Subject – Objection to SSD-93020230

40-48 Redan Street Mosman NSW 2088.

To the Commissioner of the Housing Development Authority **[HDA]**

Figure 13 Walking route to Mosman town centre

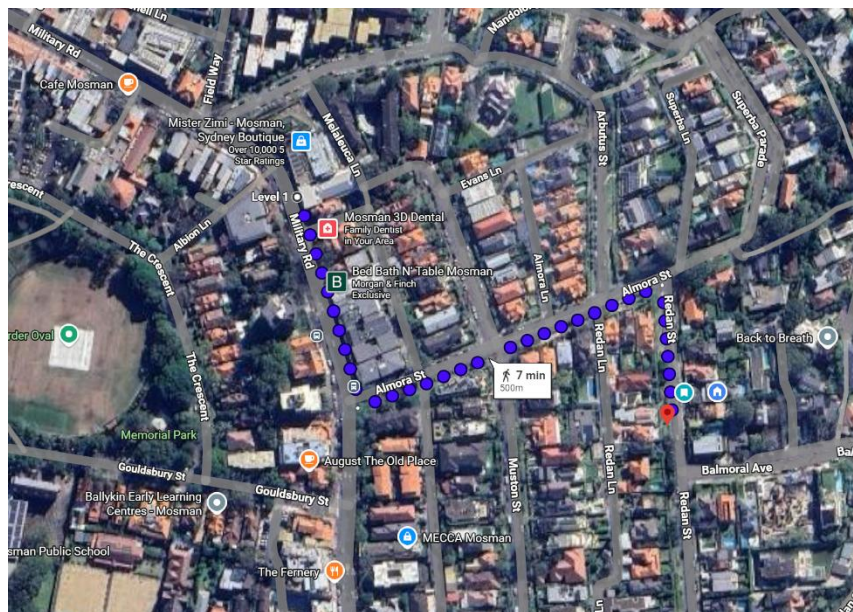
- This route is claimed to have a distance of 394.7m and accredited to LTS Surveyors.
- There is no report from LTS Surveyors included within the submission to review this calculation.

- The report presumes that the rear of a commercial premises where no public access would be permissible to that premises, is part of the Town Centre. That would be akin to arguing that you could measure the distance from a train station by measuring from the closest point of a train platform, rather than from where the public access is.

- The route appears to start on the opposing side of Malaleuca Lane from the rear warehouse service entry to the property at 742 Military Road.
- The route proposes walking along the northern side of Malaleuca Lane which does not have a public footpath, and is fully parked out for most times the day.

- The path on the southern side of Malaleuca Lane is approximately 600mm wide does not meet Council's standard of a minimum 1200mm for a pedestrian footpath

- As such, an independent assessment of safe walking distance needs to be undertaken.
- The public access to the property at 742 Military Road, is not in the rear of the commercial premises in Melaleuca Lane, and must be measured from the public access to the Town Centre. This should be measured from entrance to the building at 742 Military Road.

- Sheet 2112

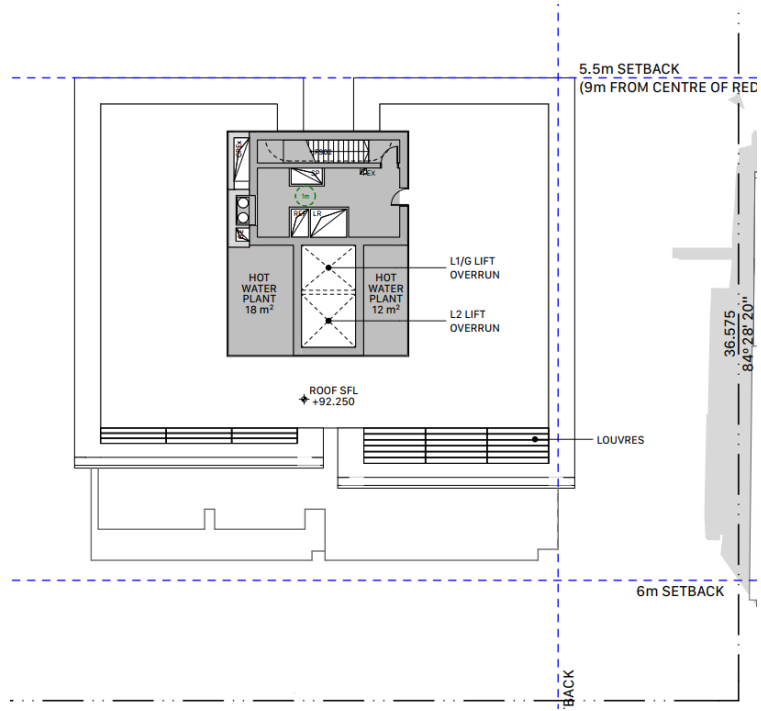
- There is also a misrepresentation in the Architectural Plan Set. Please review the elevations shown on Drawing 3003.
 - It shows that the roof over the rooftop plant is at RL 93.900

- On the far left presentation of RL's of each floor, it reflects that there is a roof height for the 'Roof' level at 95.350.
 - That roof at 95.350 is not shown on the elevations on sheet 3003

- Yet, when you look at the floor plan for the roof there is an additional roof plate without an accurate RL, that shows solar panels on a roof structure above the previous roof plan. See sheets 2112 and 2113

- This may be a subversive way to create an 11th storey, and may be utilised for something like a Community Open Space for the northern tower.
 - If this were to be so, it would be a further breach of the height and FSR calculations
 - I believe the HDA should seek written undertakings from the developer that they are not to utilise add roof space for additional structure above what is shown on their application.
- What is most worrisome is, that should this be approved, it will potentially set a precedent for other developments to similarly to breach the SEPP allowances

Figure 15 View of massing model from the east

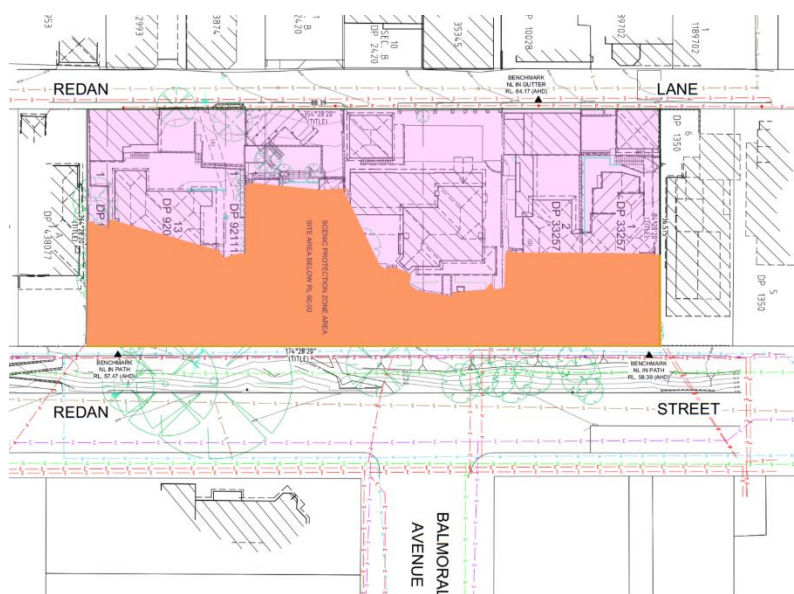
Extract of the north and east elevation plan is provided below.

- Of particular concern in this proposal is the limited articulation in the building. Storeys 4 to 9 have straight vertical walls of glass, and look like an office tower.
